C-14-08, November 25, 2014

Outdoor Control Alert Code 415 on Dave Lennox Signature® Collection Outdoor Units

XC/XP17 and XC/XP21 with Outdoor Control 103369-xx and XC/XP25 with Outdoor Control 103686-xx

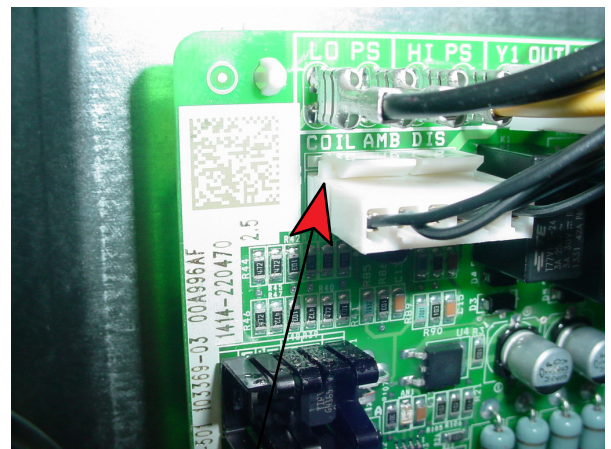
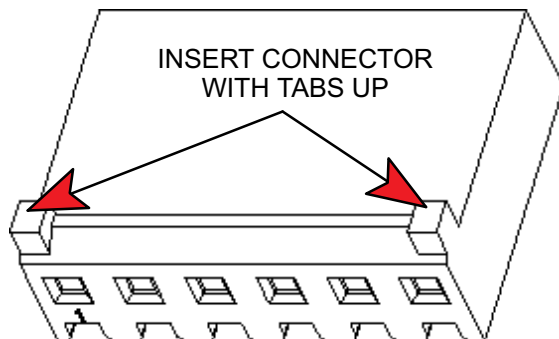
Sensor wire harness plugged in upside down. The result is the discharge sensor and coil sensor are reversed. The two sensors have different resistance value ranges. Because of this, a code 415 will be displayed on the outdoor control and iComfort® room thermostat.

Unplug sensor harness, rotate 180 degrees and plug back in. This will locate the coil and discharge sensors to the proper pin connections on the outdoor control.
